Access Compliance Report

Public Rights-of-Way

(Curb Ramps)

Intersection ID: 10036601	Main Street: RUSHMORE_DR	Cross Street: N/A	Location: NE
ADA ID: 8CFA006BE555	Ramp Type: Perp	Initial Pass/Fail: Fail	Overall Compliance: No
Codes/Mitigation Info/Possible Solution		Field Measurements/Component Compliance	
Severity Score: 55

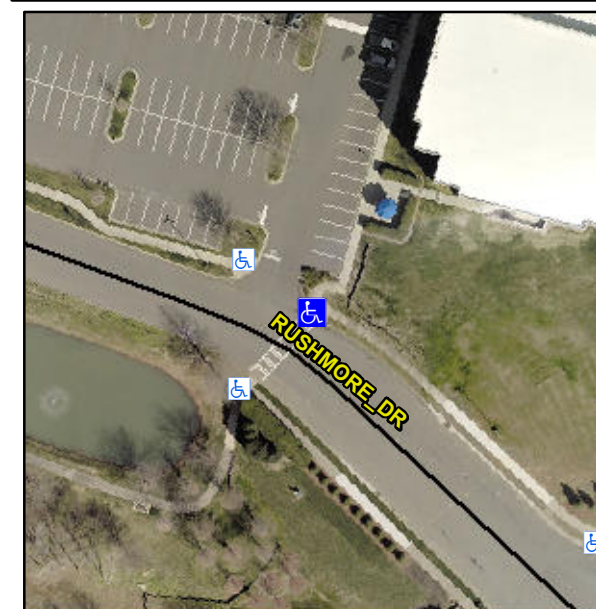
Not Found, R304.5.1, R304.2.2, R304.5.3

Compliance	Description	Data	Compliance	Description	Data
N/A	Ramp Length (in)	109.0	No	Ramp Slope (%)	9.9
No	Ramp Width (in)	32.0	No	Ramp XSlope (%)	9.9
N/A	Flare Type LT	N/A	N/A	Flare Type RT	N/A
N/A	Flare Slope LT (%)	N/A	N/A	Flare Slope RT (%)	N/A
N/A	Flare Traversable LT?	N/A	N/A	Flare Traversable RT?	N/A
N/A	Landing Length (in)	N/A	N/A	DWS Provided?	N/A
N/A	Landing Width (in)	N/A	N/A	DWS Contrast?	N/A
N/A	Landing Slope (%)	N/A	N/A	DWS Length (in)	N/A
N/A	Landing X Slope (%)	N/A	N/A	DWS Full Width?	N/A
N/A	Landing Curb? (Y/N)	N/A	N/A	DWS Offset (in)	N/A
N/A	Shared Landing?	N/A			
N/A	Gutter Ponding?	N/A	N/A	Gutter Slope (%)	N/A
N/A	Gutter Lip Ht (in)	N/A	N/A	Gutter X Slope (%)	N/A
N/A	Painted X Walk1?	Yes	N/A	Painted X Walk2?	N/A
	X Walk 1 Direction	To SW		X Walk 2 Direction	N/A
N/A	X Walk 1 Width (in)	87.0	N/A	X Walk 2 Width (in)	N/A
	X Walk 1 Slope (%)	2.9		X Walk 2 Slope (%)	N/A
	X Walk 1 X Slope (%)	4.5		X Walk 2 X Slope (%)	N/A

Remove & Replace Entire Ramp.
